Docket Item # 3
BAR CASE # 2016-0406

BAR Meeting
September 27, 2017

ISSUE: UPDATE: Certificate of Appropriateness – New Construction
APPLICANT: VHD LLC
LOCATION: 699 North Patrick Street
ZONE: CRMU-M

Conditions of Approval

Condition 3:

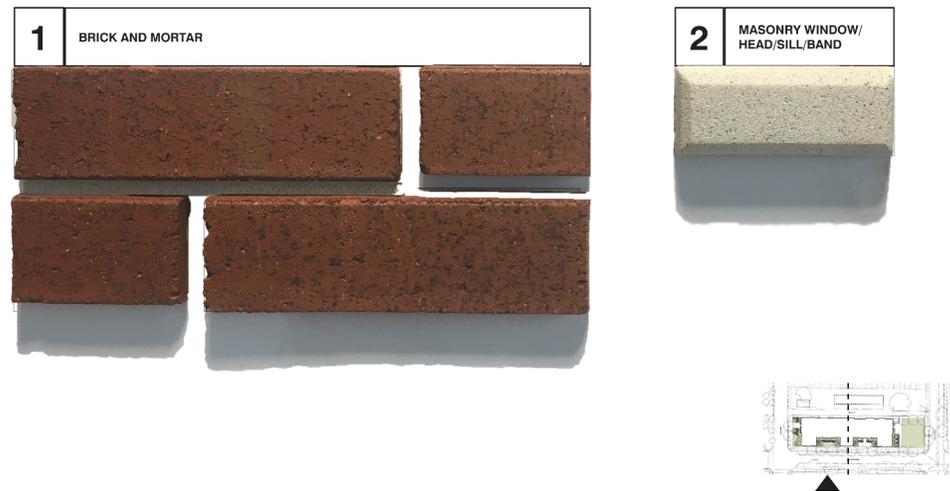
Select a slightly warmer precast stone and mortar color to better coordinate with the brick.

The applicant has worked with staff to achieve the desired result.

EXTERIOR CORNER DETAILS

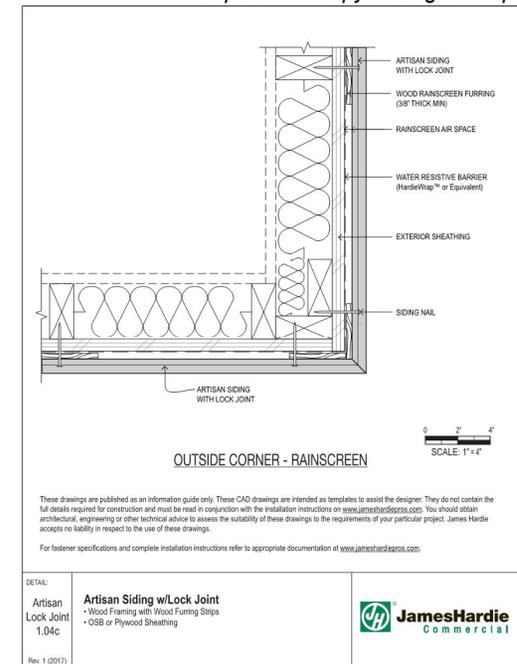
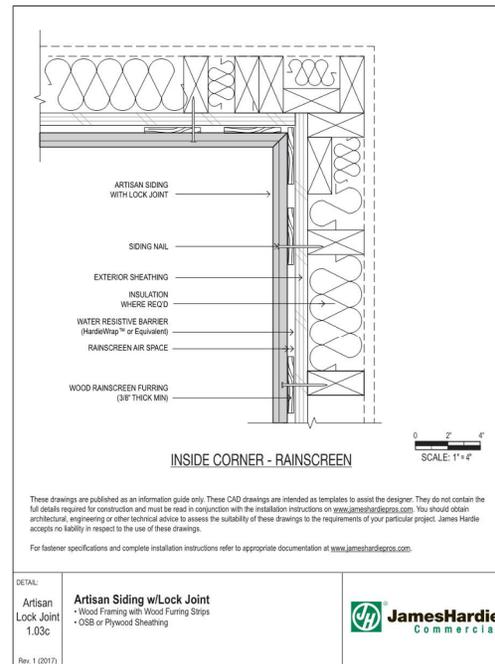
Detailing of the horizontal siding, with special attention to the corner treatment where siding is proposed.

The applicant has provided the James Hardie Artisan V-Groove Siding details indicating the construction at corner conditions.
